**Meeting Presentation
RCRA Corrective Action
RFI Phase I Results and Phase II
Recommendations
General Chemical Corporation
Delaware Valley Facility**

**USEPA Region III/DNREC
November 7, 2003**

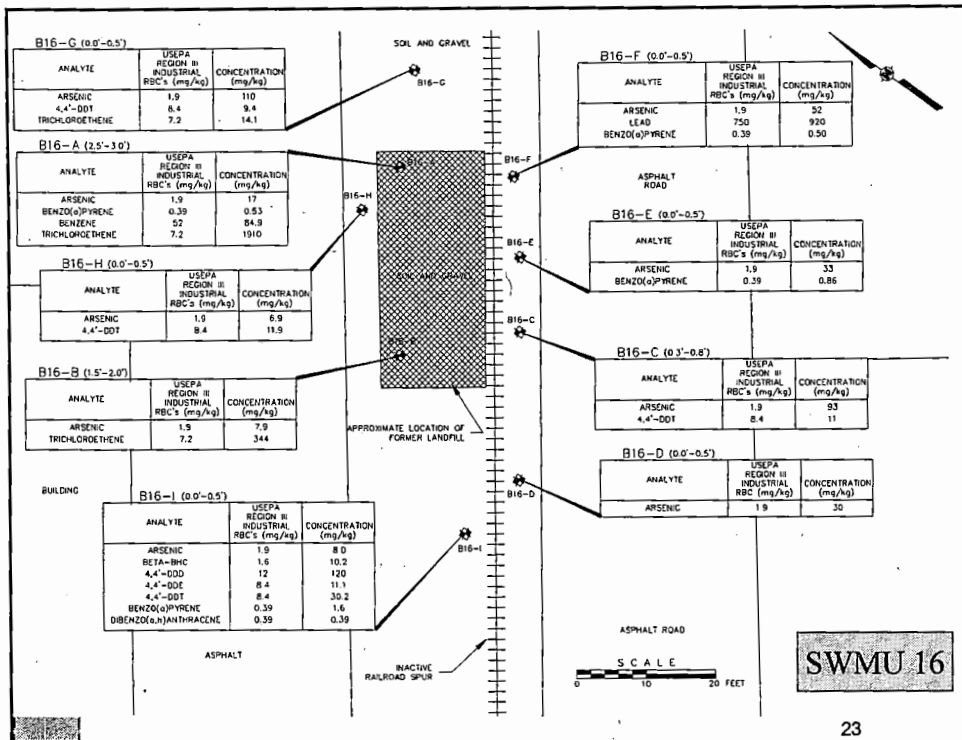
depth?

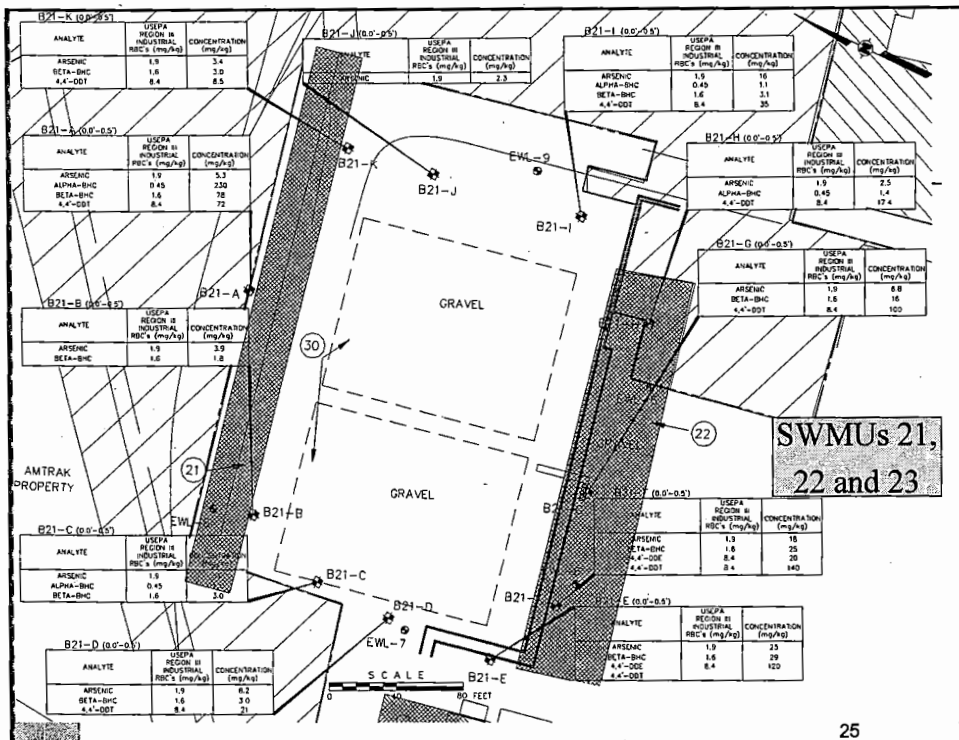
<p>SWMU 16</p>	<ul style="list-style-type: none"> Trichloroethene above RBC in 3 samples (14.1, 344, and 1910 ppm); benzene above in one sample Arsenic above RBC but less than 10 ppm at three locations Arsenic, 19 to 110 ppm at the other six locations Pesticides above RBCs at four locations PAHs (low ppm levels) Lead slightly above RBC at one location 	<ul style="list-style-type: none"> Extent of Past Landfill Area IV defined Two highest TCE concentrations and benzene detected within former landfill area (split samples with USEPA) Only one sample outside source area above TCE 10^{-6} RRBC (B16-G) Asphalt paving in all directions except a 20 foot wide corridor 15 feet NE of B16-G and 30 feet SW of B16-I. Clay layer identified beneath landfill area Disturbance of area resulted in a relatively high level of organic vapors Distribution of As and pesticides do not show pattern associated with past landfill Source of PAHs likely fill/railroad 	<ul style="list-style-type: none"> No further characterization; landfill and adjacent unpaved areas will be addressed using appropriate corrective action measures <p><i>need to address gas partitioning</i></p>

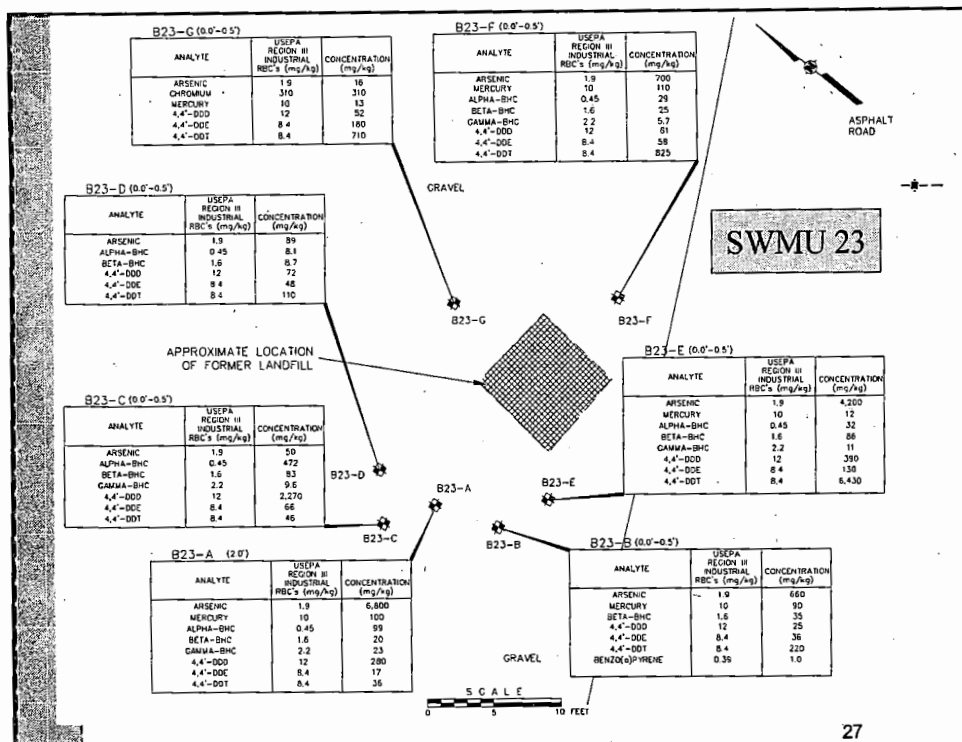
<p>SWMU 21, 22, and 30</p>	<ul style="list-style-type: none"> • Arsenic for most samples below 10 ppm; max. of 25ppm • Pesticides at low levels in most samples; higher levels in 4 samples 	<ul style="list-style-type: none"> • Using a 10⁻⁵ risk RBC results in only 4 locations above RBCs. • Arsenic concentrations below accept cleanup levels • Sampled area and SWMUs are covered with an approximate 6 inch layer of gravel • Concentrations sporadic around unit. • Honeywell property adjacent on three sides • General Chemical property south recently paved • Remaining property south and west unpaved 	<ul style="list-style-type: none"> • No further characterization; landfill and adjacent unpaved areas will be addressed using appropriate corrective action measures <p><i>IF SW OK - paving OK</i></p>
----------------------------	--	--	--

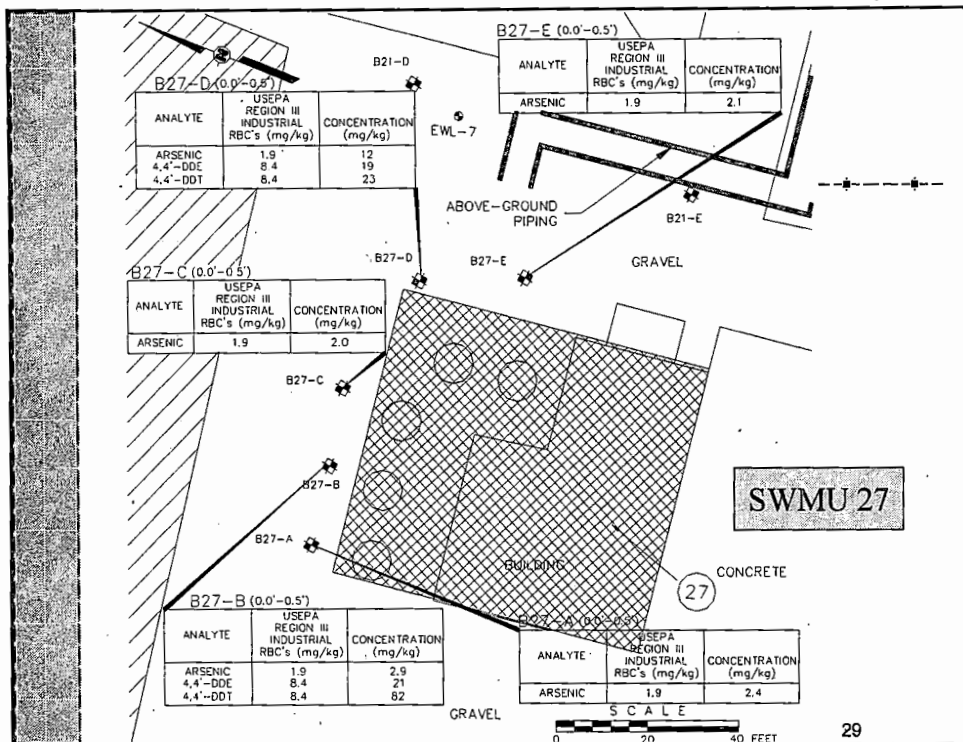
<p>SWMU 23 <i>1/6 to 1/10</i></p>	<ul style="list-style-type: none"> • Arsenic relatively high in several sample locations (660 to 6,800 ppm) • Sample at depth (2.0') had highest concentration • Mercury at 90-110 ppm at three locations • Pesticides in all samples and as high as 2,500 and 6,500 ppm in two of the samples 	<ul style="list-style-type: none"> • Former Landfill Area XI not completely defined based on physical and chemical observations • No distinctive pattern of distribution. • The lateral extent has not been defined for any constituent above RBCs. 	<ul style="list-style-type: none"> • Six 2.0 to 2.5 foot depth samples at previous locations to assist in defining the extent of former landfill area • Collection of soil samples at six additional sampling locations in unpaved areas beyond sampling area. The collection of surface soil and 2.0 to 2.5 foot depth samples at each location to evaluate the lateral extent of relatively high concentrations of arsenic and pesticides in surface soils and further define the extent of the former landfill area • Collection of a soil sample from the 4.5 to 5.0 depth interval at four locations (B23-A, B23-E, B23-F, and B23-G) to evaluate the depth of the former landfill

depth to 9'

Groundwater Flow

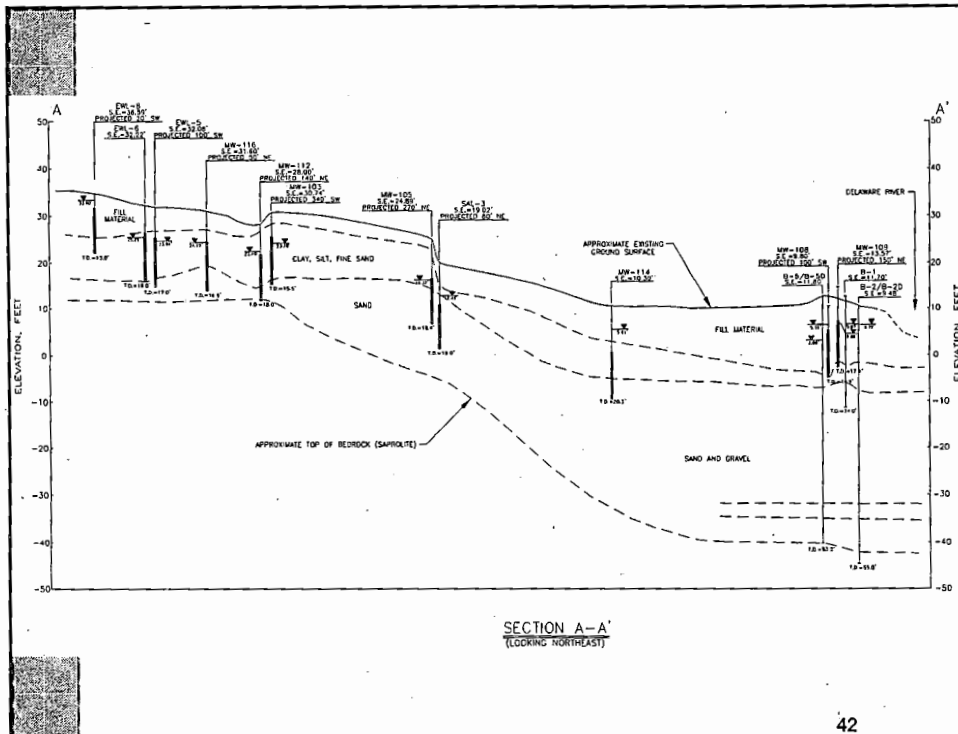
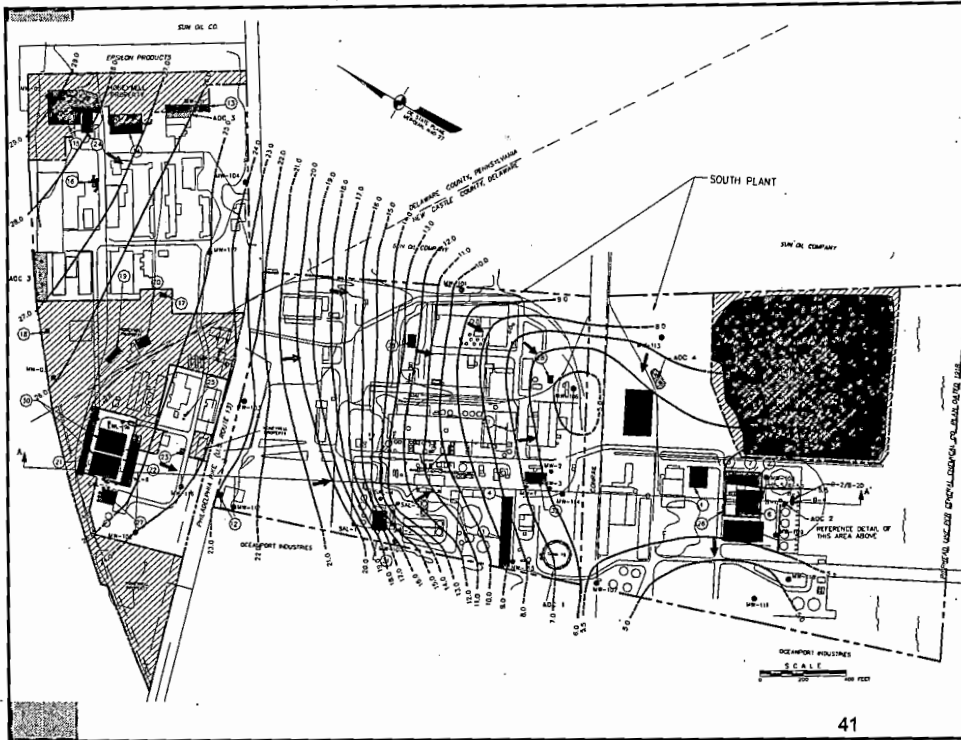
*look at
Screen depths*

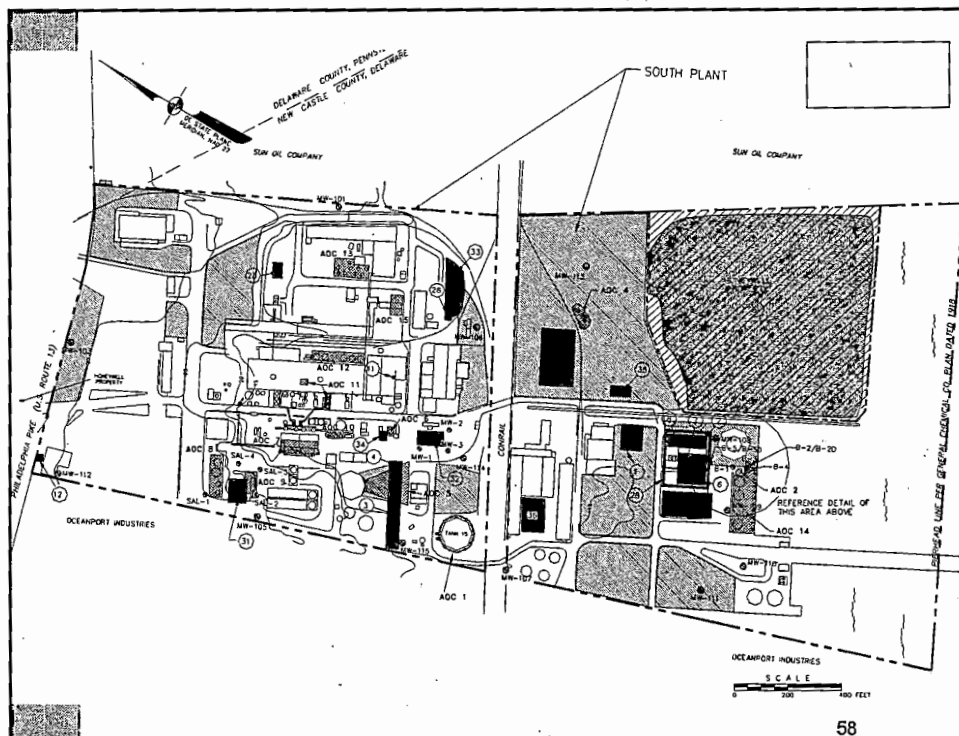
↓
not
true
MAP
